ADDENDUM 01

BID FOR : *Campus Gateways, McNeese State University, Lake Charles, Louisiana 70607*

Addendum No. 01

PROJECT:
Campus Gateways
McNeese State University
Lake Charles, Louisiana
19-627-21-01, F.19002583
01-107-05B-13, F.01004545 (Supplement)

B4 GATEWAY 04 BASE @ LIGHT BOX
SCALE: 3/4" = 1'-0"

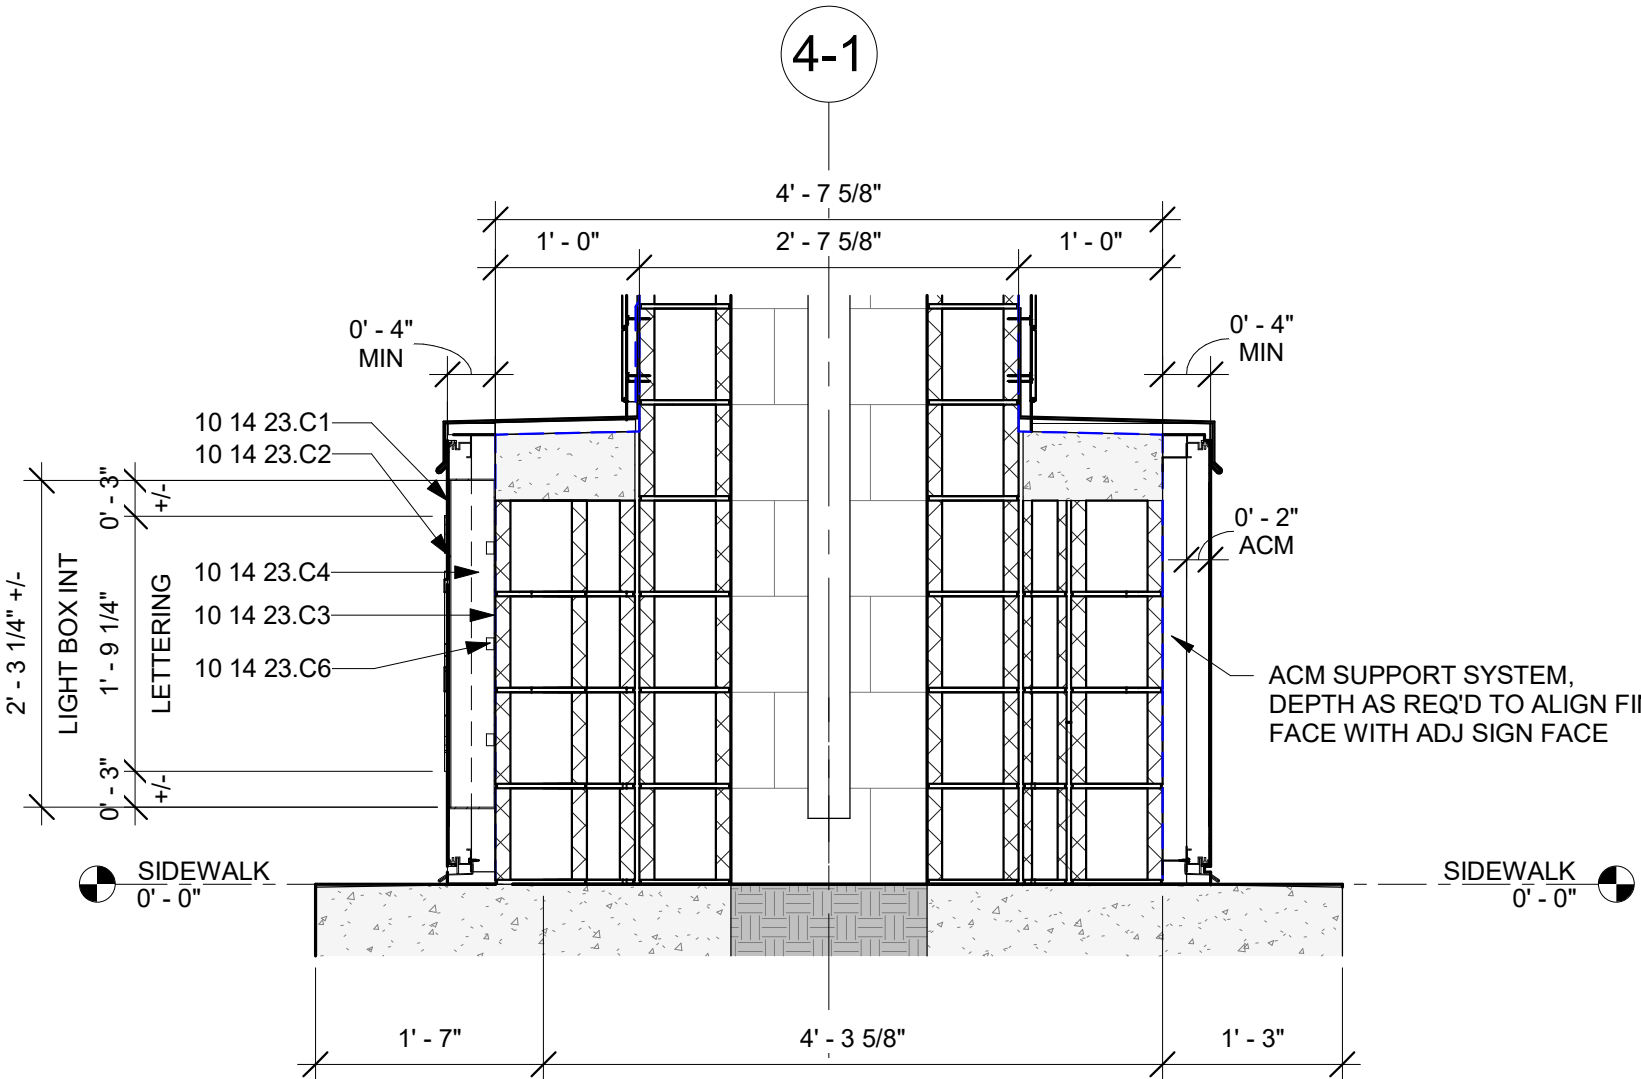
- a. Sheet A-104R1 Gateway 04- Plans and Elevations.
- b. Sheet A-105R1 Gateway 05- Plans and Elevations.
- c. Sheet A-521R1 Gateway Signage.

E102
CAMPUS GATEWAYS 03 & 05 -
ELECTRICAL PLANS

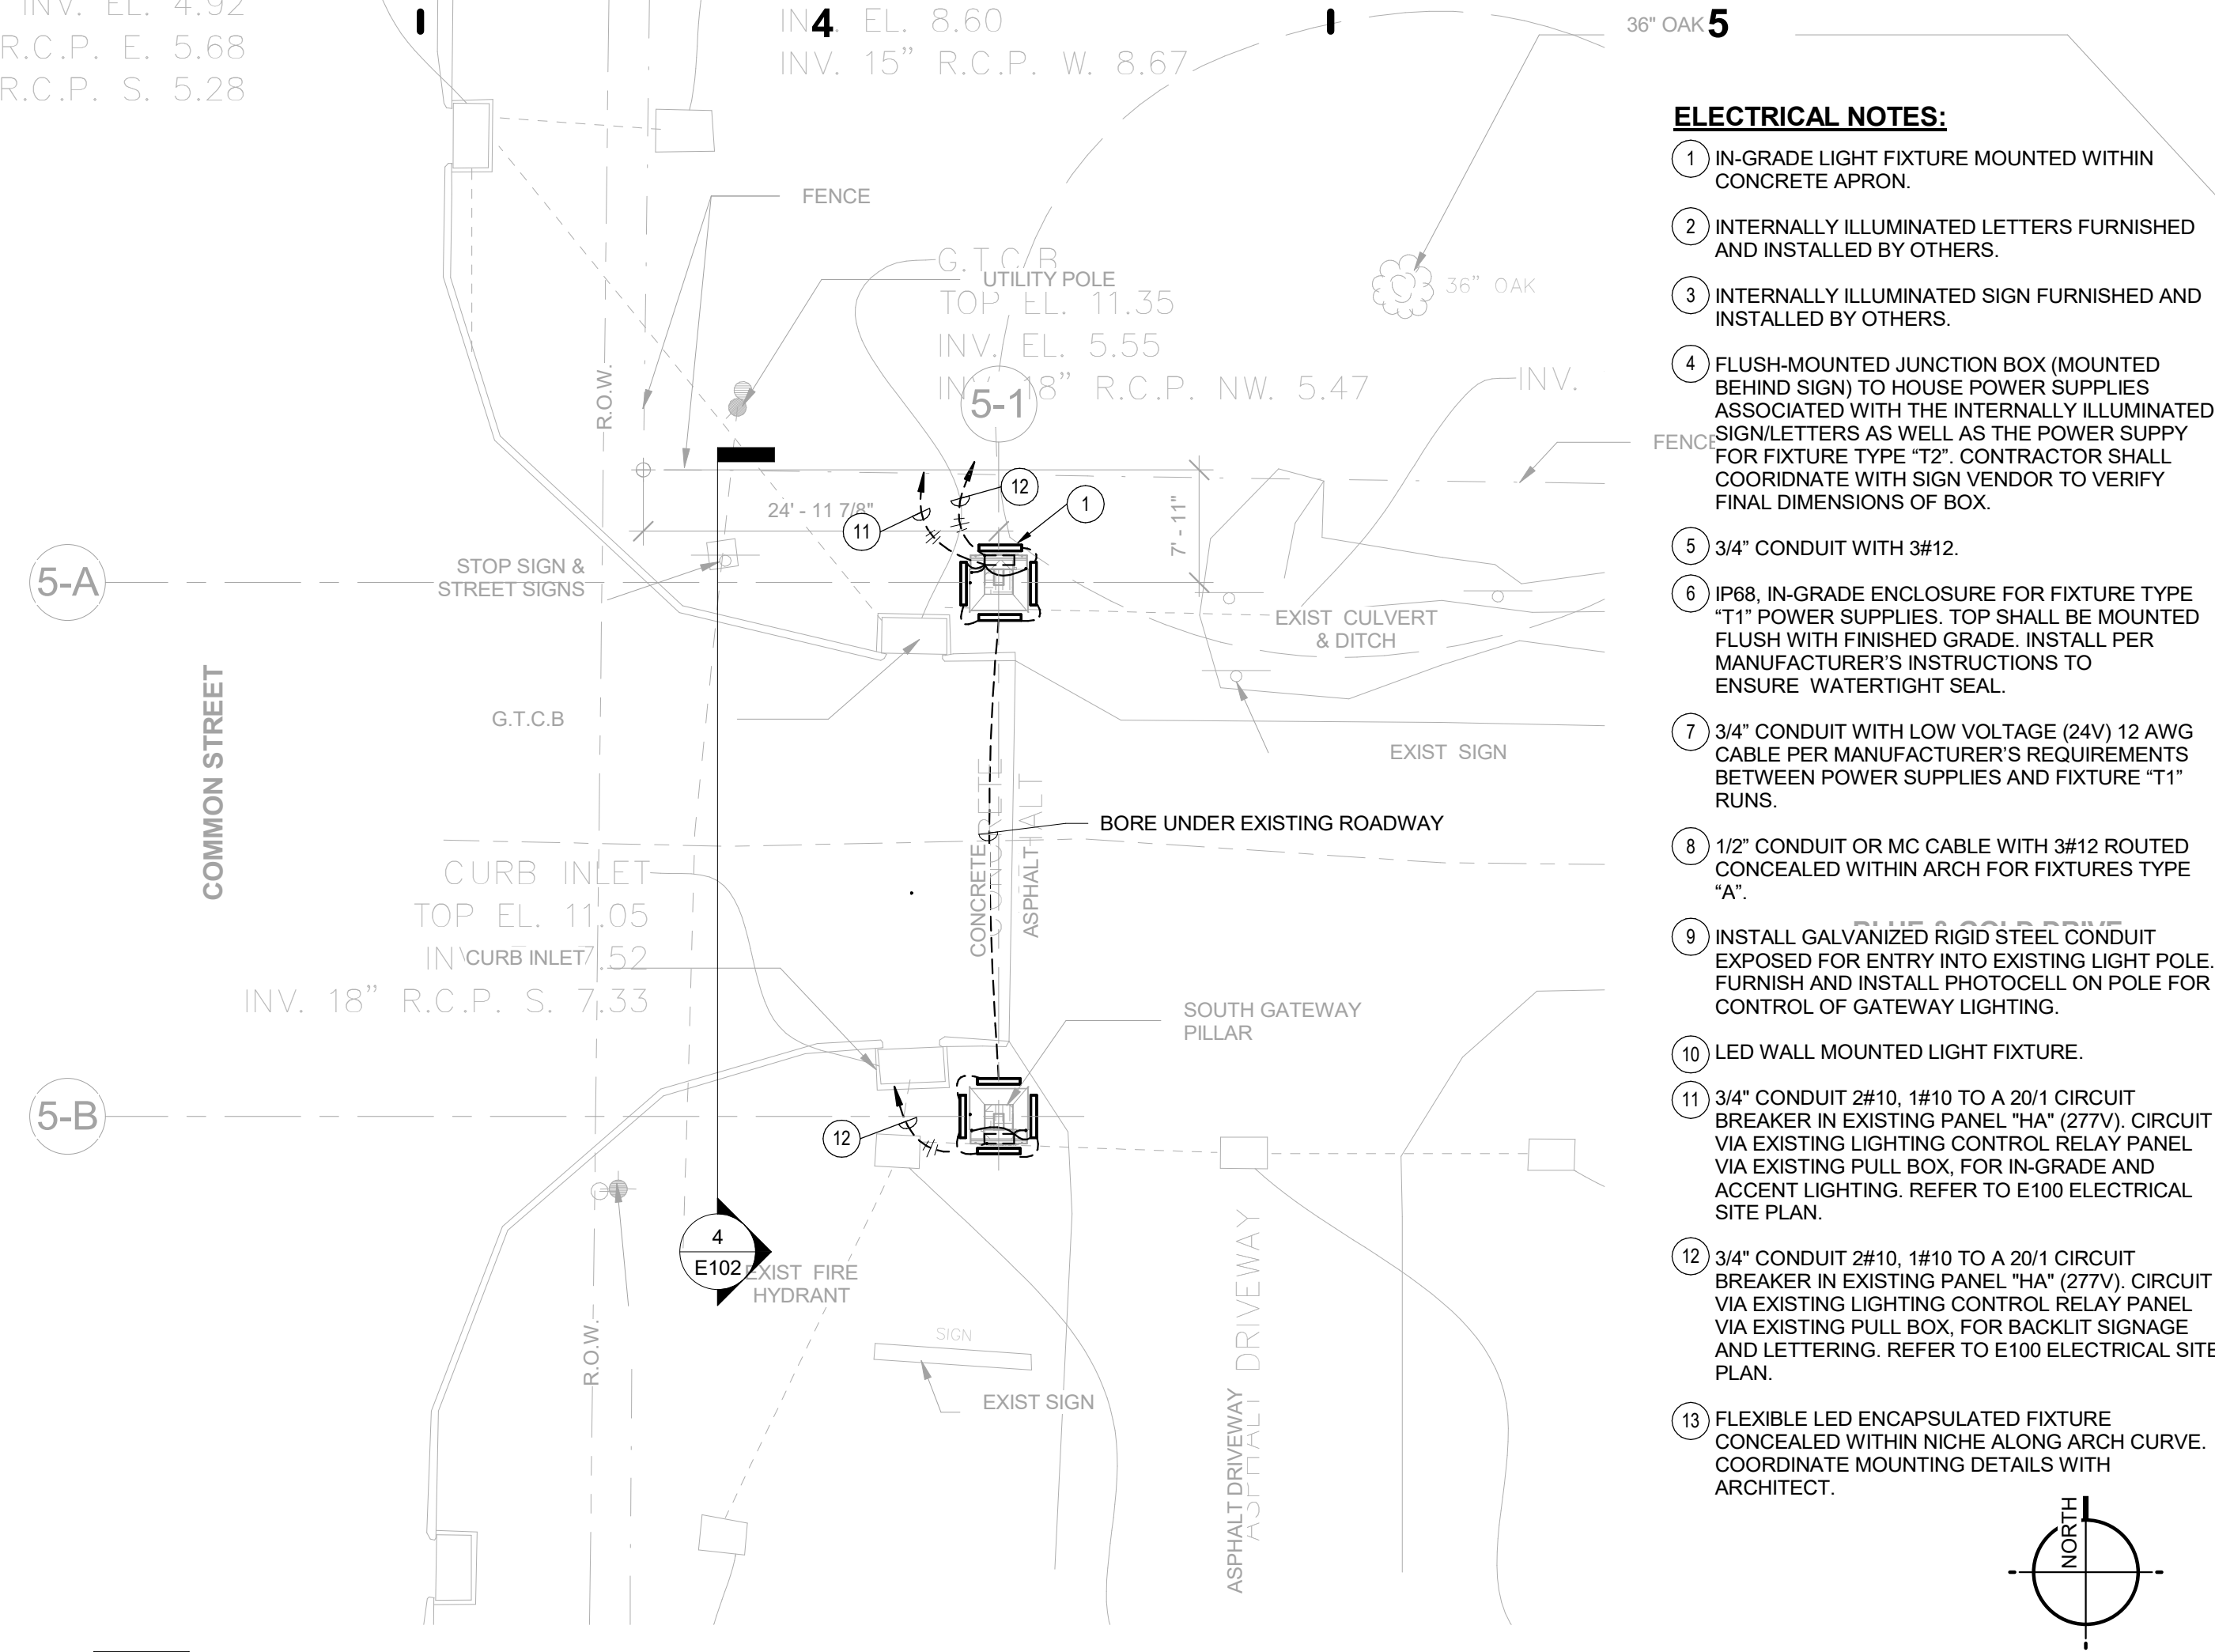
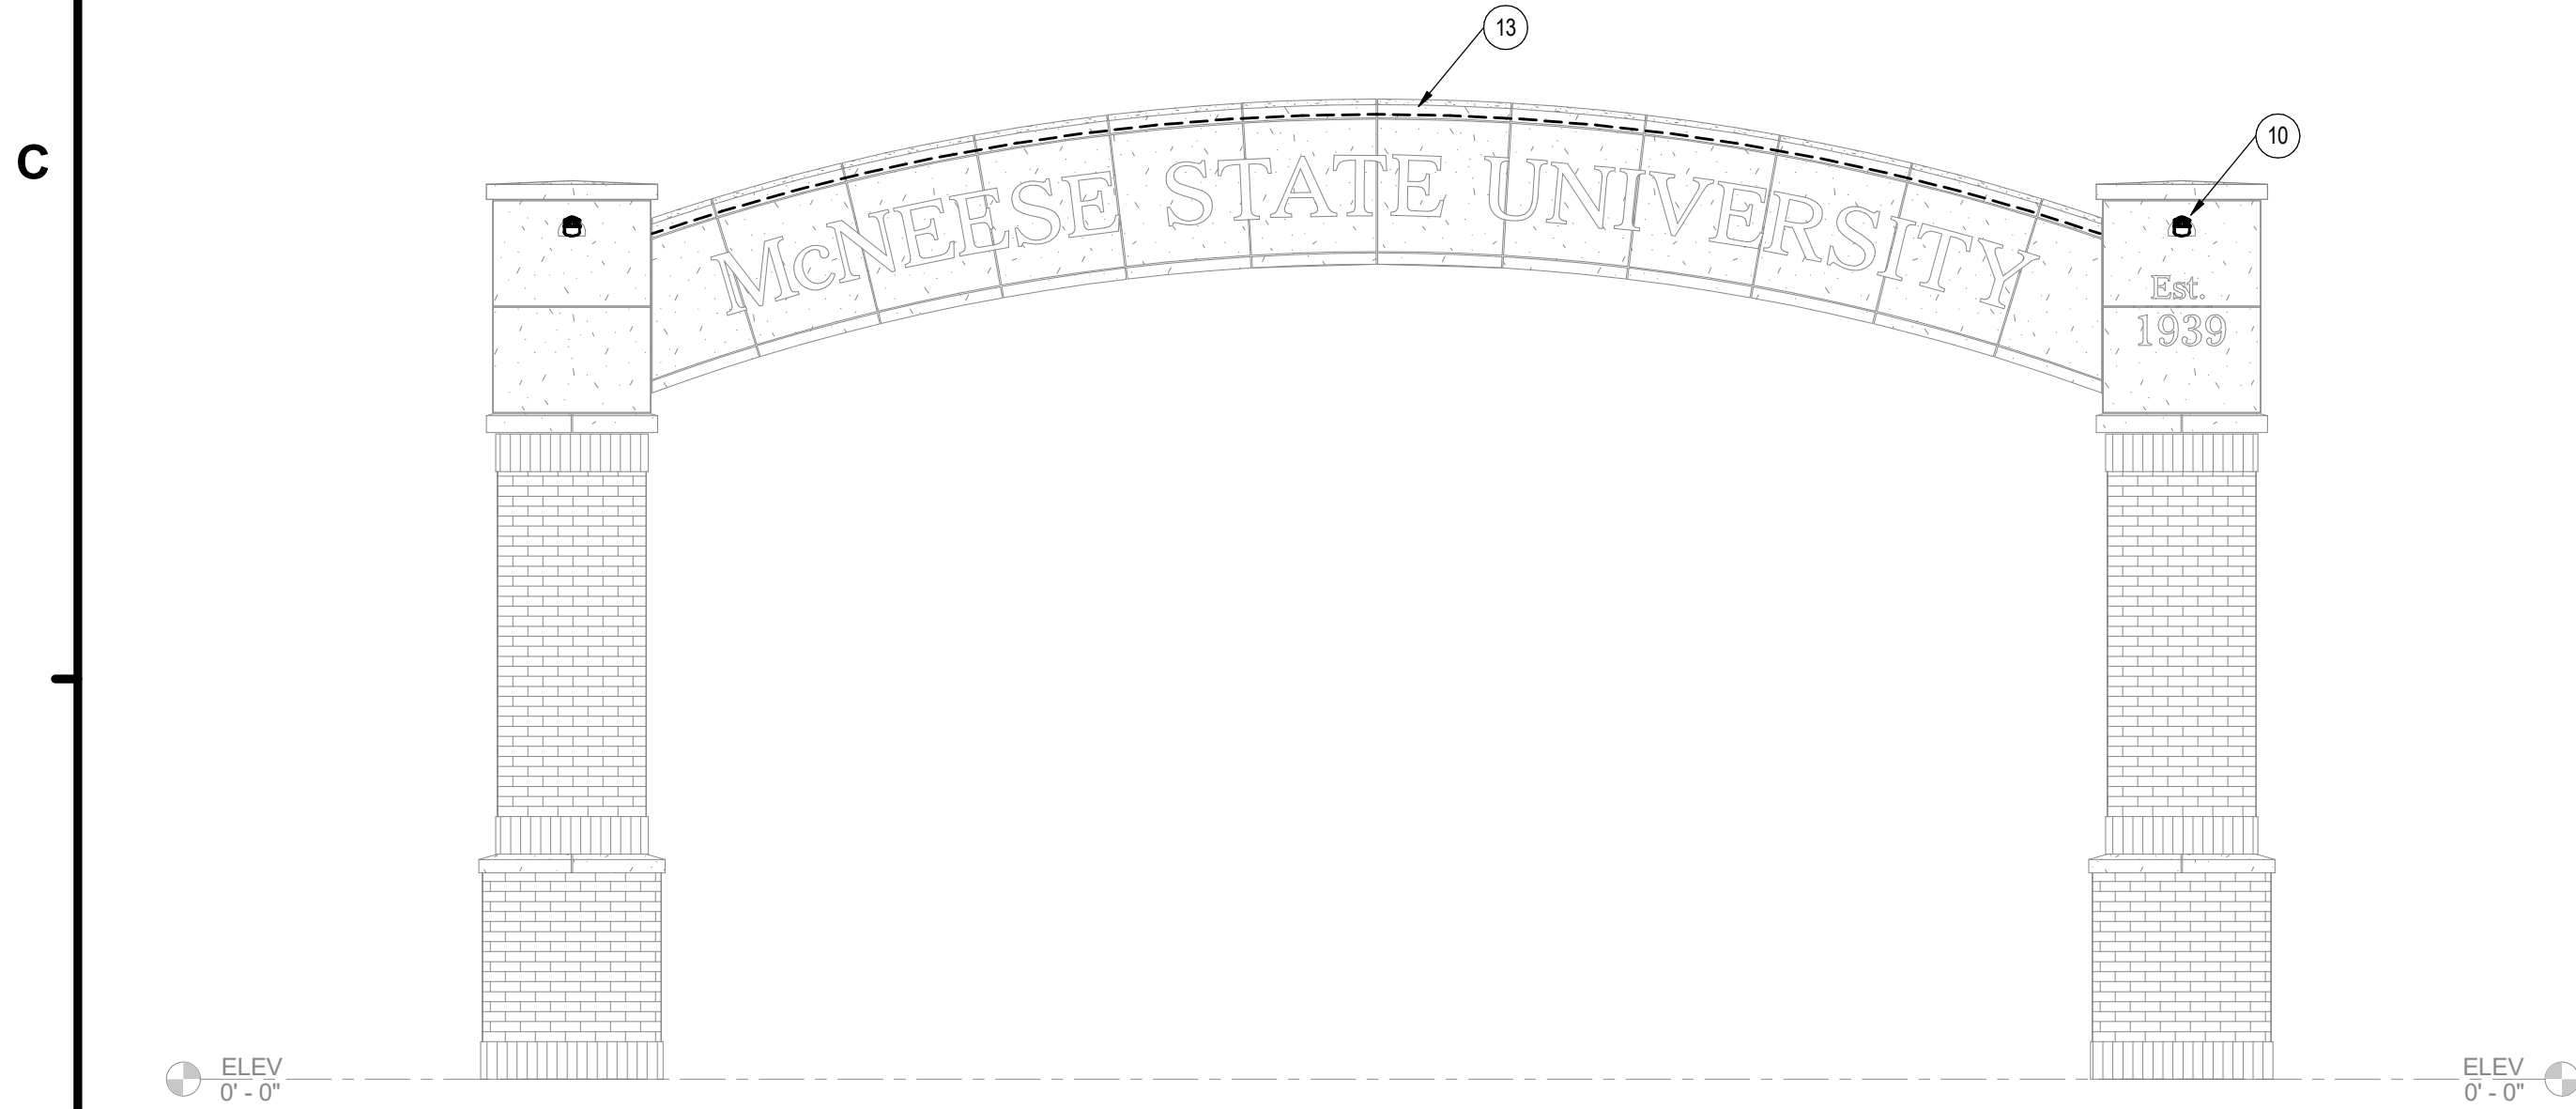
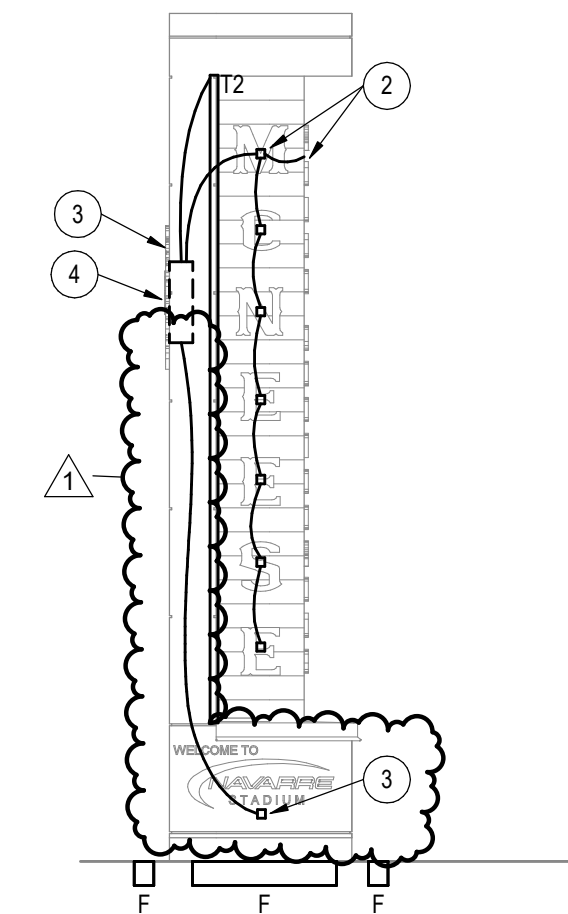
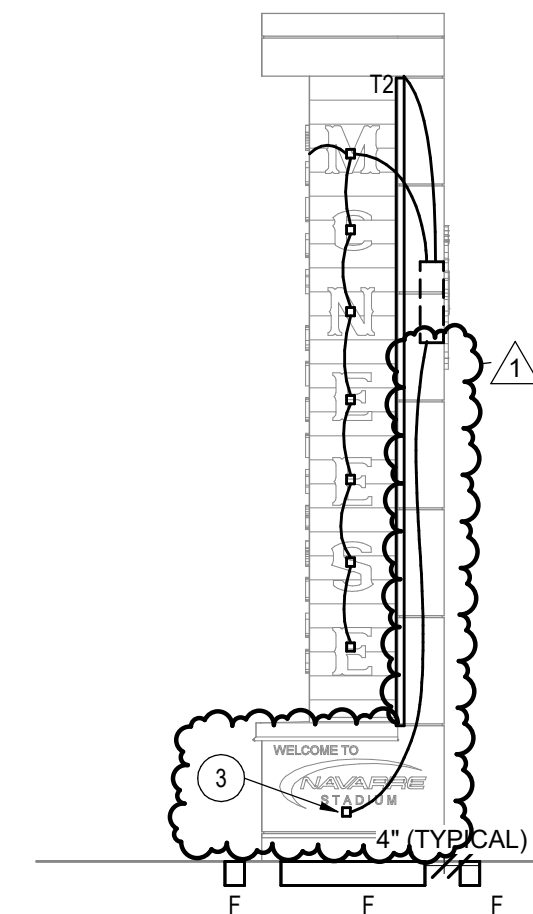
- d. Sheet E102 – Campus Gateways 03 & 05 – Electrical Plans revision 1 Seq. 1 – ADD NO. 1 dated 10/16/26.
- e. Sheet E103 – Campus Gateway 04 – Electrical Plans revision 1 Seq 1 – ADD NO. 1 dated 10/16/26.
